Office Action Summary	Application No. 10/529,154	Applicant(s) UMENO, YOSHIHISA	
	Examiner Filip Zec	Art Unit 3785

DETAILED ACTION

FIG. B, as annotated by the Examiner: Dimensions 1 and 2, defining the first and second open areas between the partition and the fan in both the radial and frontal directions

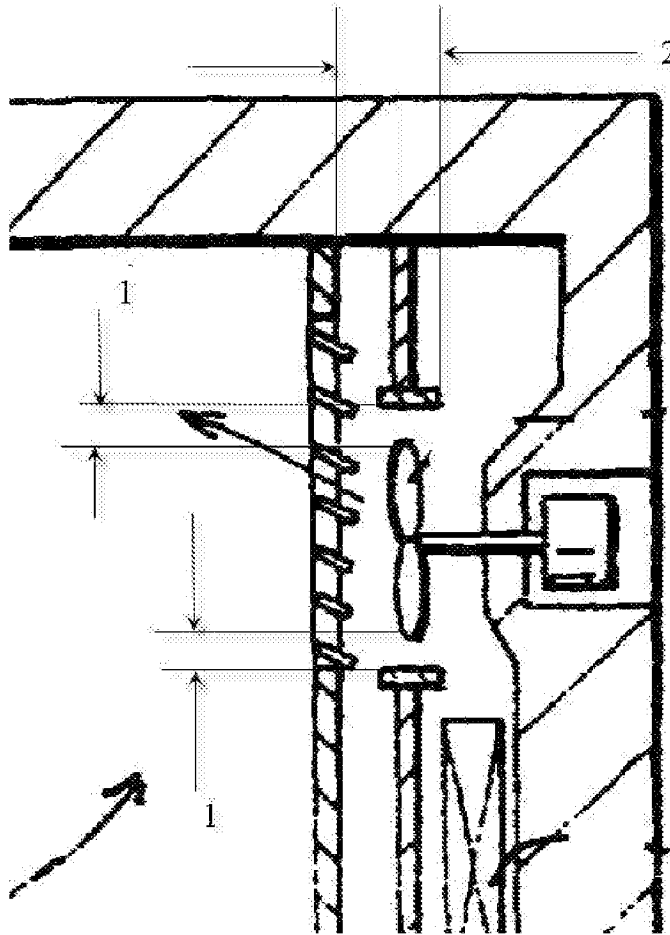
In reference to the applicant's arguments regarding the Kim reference and the inherent phenomenon of two air flow collision, looking at FIG. B (as annotated by the Examiner), the space surrounding the fan (20, FIG. A) is sufficiently open to inherently provide movement of air flow in both directions. Specifically, the first area (defined by offset dimensions 1, FIG. B) provides ample open space in the radial direction and the second area (defined by offset dimension 2, FIG. B) provides ample open space between the partition and the fan. Again, it has been held that a claim is anticipated if each element of the claim is found, either expressly described or under principles of inherency, in a single prior art reference, or that the claimed invention was previously known or embodied in a single prior art device or practice. *Kalman v. Kimberly-Clark Corp.*, 218 USPQ 789. Also, it is elementary that the mere recitation of a newly discovered function or property, inherently possessed by things in the prior art, does not cause a claim drawn to distinguish over the prior art. Additionally, where the Patent Office has reason to believe that a functional limitation asserted to be critical for establishing novelty in the claimed

FIG. A, as annotated by the Examiner: A Cooling Device

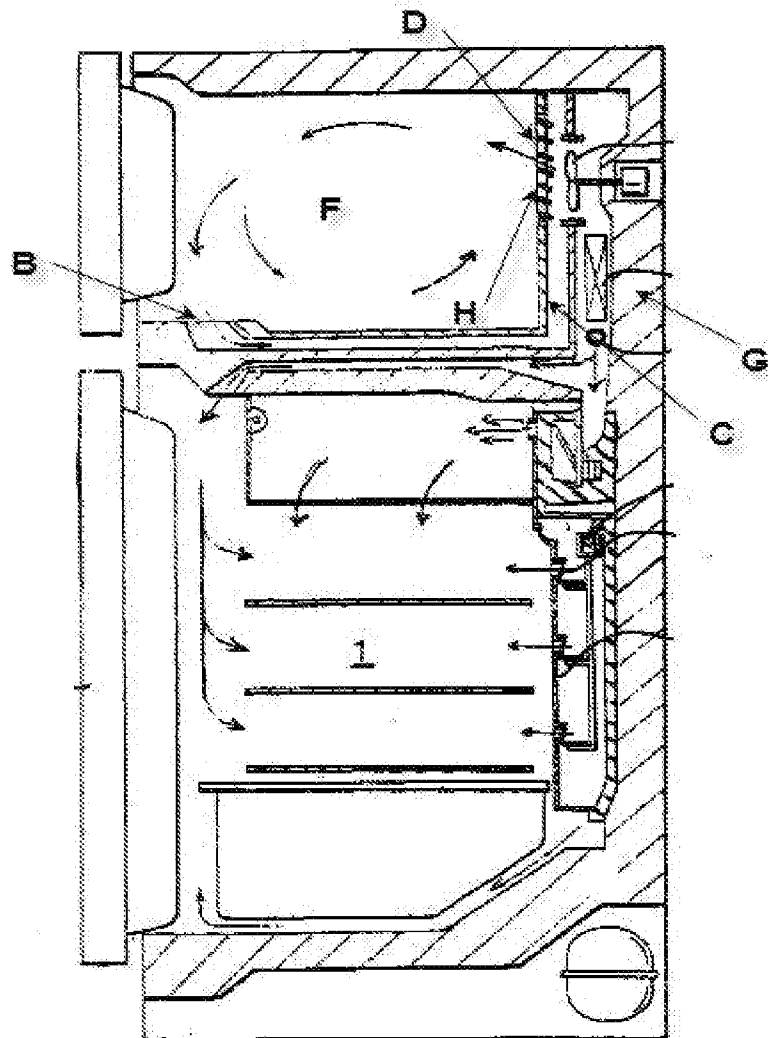
In reference to claim 1, Kim teaches a cooling device (FIG. 2) comprising a cooler (11, FIG. 2) provided on at least one side-wall side (G, FIG. A, as annotated by the Examiner) formed with a thermal insulating box (inherent in a freezer construction as shown in Kim, see FIG. 2); a

cooling chamber (F, FIG. A) in front of the cooler (11, FIG. 2); and a fan (20, FIG. 2) that allows air in the cooling chamber to flow, wherein the cooler and the cooling chamber are partitioned by a partition (C, FIG. A) so as to allow cold air to be accumulated in the cooler, the fan (20, FIG. 2) is disposed on a side of the cooler (11, FIG. 2) relative to the partition (C, FIG. A), the partition in front of the fan (20, FIG. 2) has an aperture (D, FIG. A) formed in a flat sheet portion (above and below partition C, FIG. A), a first open space is formed between the fan and the flat sheet portion in which the aperture is formed (as defined by dimensions 1 plus fan propeller length and 2, FIG. B, above) and a second open space is formed outside the fan in the radial direction (as defined by dimensions 1 plus fan propeller length and propeller width, FIG. B above), cold air accumulated in a space inside the partition, and hot air in the cooling chamber are exchanged by the fan (20, FIG. 2) through the aperture (D, FIG. A), wherein the rotation of the fan generates a discharged flow of cold air discharged from the cooler to the cooling chamber through the aperture and a sucked flow of cold air sucked from the cooling chamber to the cooler through the aperture, and the discharged flow and the sucked flow directed from the cooling chamber to the cooler collide with each other in a portion in which the aperture is provided (inherent in the structure as described in Kim, see FIG. 2), but does not teach that the perimeter of the fan is not surrounded by a cylindrical component. Lazar teaches a forced convection evaporator (FIG. 3) wherein a fan (58, FIG. 3) is located inside the casing (2, FIG. 3) and wherein said fan is not surrounded by a surrounding component in order to allow the fan to suck the cooled air from entire space inside of the casing, including the bottom area of the casing (where the evaporator 28 is located) and disperse said area in the opposite direction towards the discharge (66, FIG. 2 and 4) and thus increasing the efficiency of the refrigerating system (col 2,

In reference to claim 2, Kim, Lazar and Clark disclose the cooling device as explained in the rejection of claim 1, and Kim also teaches that dimensions of the aperture (D, FIG. A) are larger than a diameter of the fan (20, FIG. 2).

In reference to claim 3, Kim, Lazar and Clark disclose the cooling device as explained in the rejection of claim 2, and Kim also teaches that when viewing the fan (20, FIG. 2) in a

direction of a rotation shaft of the fan, the fan is disposed in the aperture (D, FIG. A) and there is an open space outside the fan (in front and around of fan 20, FIG. 2).

In reference to claim 5, Kim, Lazar and Clark disclose the cooling device as explained in the rejection of claim 1, and Kim also teaches that the discharged airflow and the sucked flow collide with each other, thus suppressing the flow speed of the cold air (inherent in the structure as described in Kim, see FIG. 2 and FIG. A).

In reference to claim 8, Kim, Lazar and Clark disclose the cooling device as explained in the rejection of claim 1, and Kim also teaches that a slit (B, FIG. A) is formed in the partition (C, FIG. A) at a portion below the cooler (11, FIG. 2).

In reference to claim 10, Kim, Lazar and Clark disclose the cooling device as explained in the rejection of claim 1, and Kim also teaches that a safety cover (grille H, FIG. A) is disposed over the fan aperture (D, FIG. A).
